Groundwater Application Review Summary Form

Application # G- 18803 (re-review)

PUBLIC INTEREST REVIEW FOR GROUNDWATER APPLICATIONS

TO: Water Rights Section Date January 23, 2020
 FROM: Groundwater Section Travis Brown
 Reviewer's Name
 SUBJECT: Application G- 18803 Supersedes review of June 14, 2019 (changes in red)
 Date of Review(s)

Hydrographs

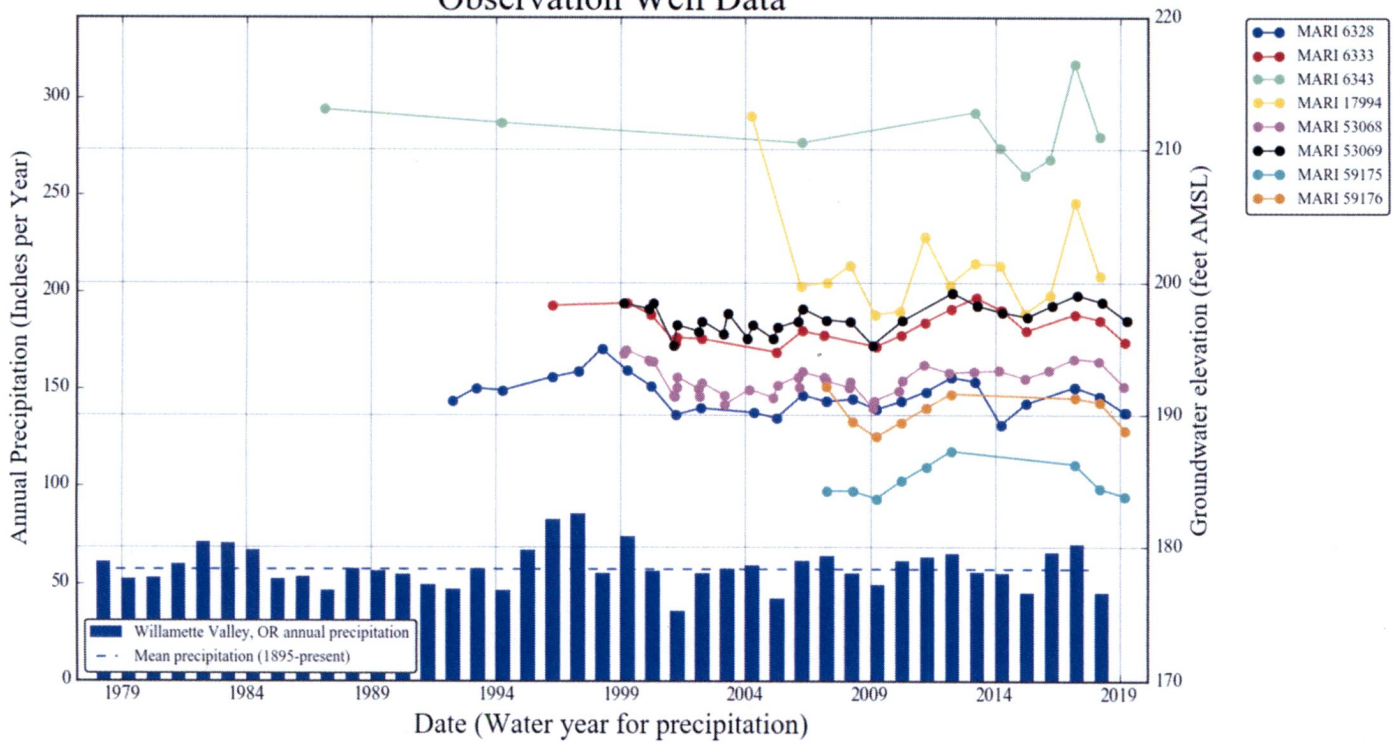
Water levels from nearby observation wells completed in the CRBG aquifer(s) suggest that other groundwater users are using the same aquifer which would be tapped by the proposed POA (see attached Hydrograph). The available water level data does not indicate widespread or consistent declines in the local basalt aquifer over the past decade. However, because pumping impacts will propagate outwards at rapid rates and likely reach the aquifer boundaries, conditions in the aquifer may change quickly.

Well Statistics

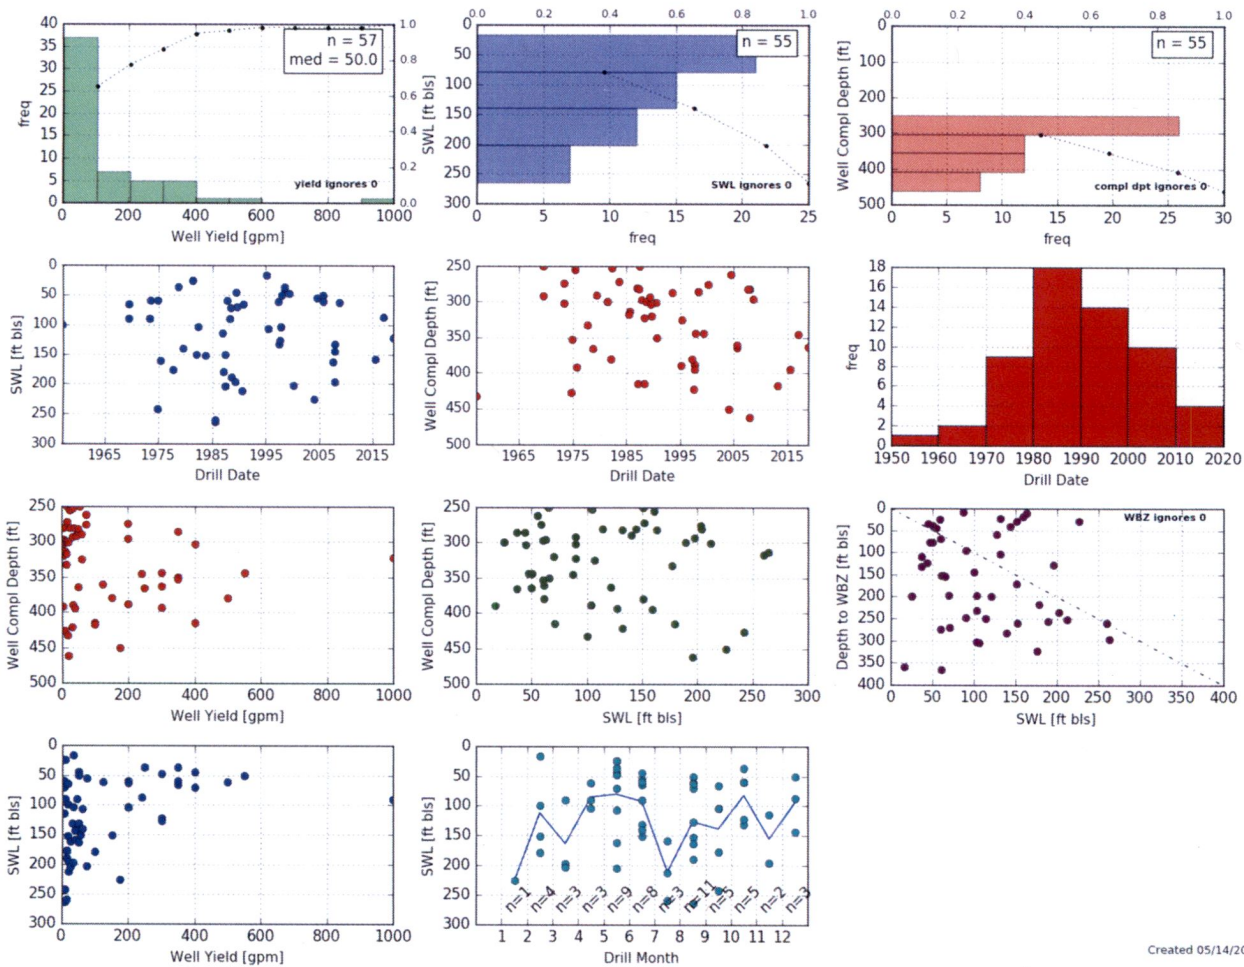
Well statistics for basalt wells completed to similar depths in Sections 17 to 20 of T7S/R1W indicate reported yields ranging from 5 to 1000 gpm, with a median of 50 gpm. To achieve the requested use of 0.895 cfs (401.5 gpm), each of the applicant's proposed wells would need to yield greater than ~200 gpm (~0.446 cfs), which is ~400% of the median reported yield for nearby basalt wells but still within the range of reported yields (see Well Statistics, attached).

Drawdown Analysis – POA 1

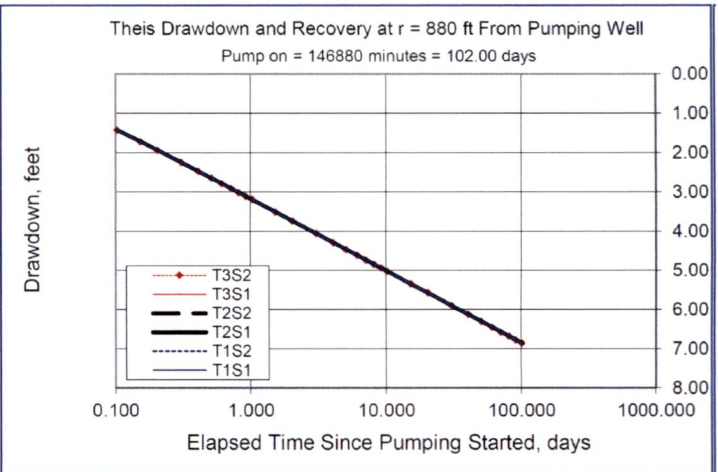
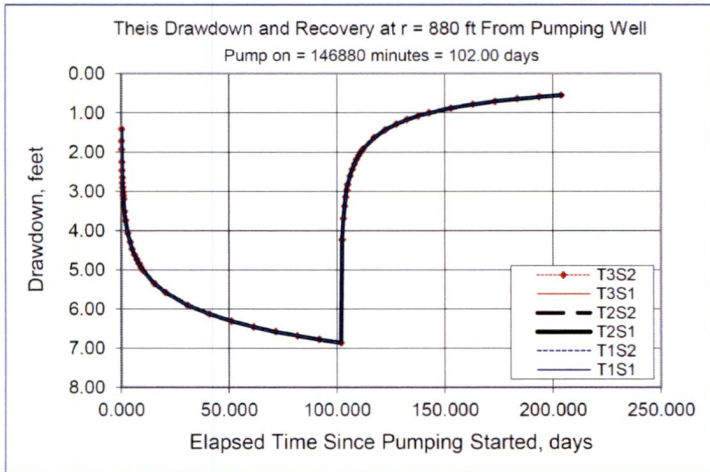
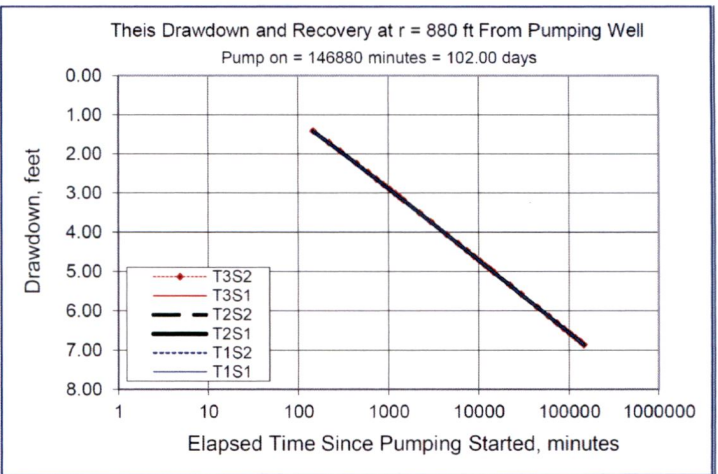
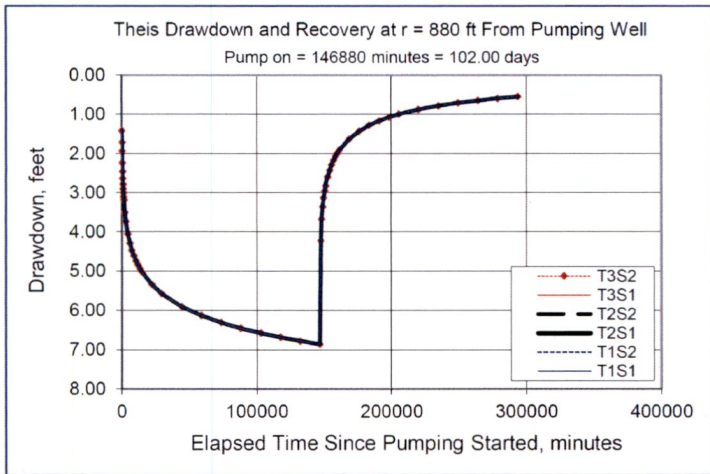
To evaluate the potential interference at MARI 6335 due to the proposed use, a Theis (1935) drawdown analysis was conducted. Hydraulic parameters used for the analysis were derived from regional data and studies (Pumping Test Reports; Conlon et al., 2005; McFarland and Morgan, 1996; Woodward et al., 1998) or are within a typical range of values for the given parameter within the hydrogeologic regime (Domenico and Mifflin, 1965; Freeze and Cherry, 1979). Results of the analysis indicate that interference with MARI 6335 is unlikely to exceed 15 ft within the conservative scenario of more than 100 days of continuous pumping from both proposed POA simultaneously at 94 gpm each (total 188 gpm / ~0.419 cfs) (see attached Drawdown Analyses. **Note: Drawdowns from POA 1 and 2 are additive).**
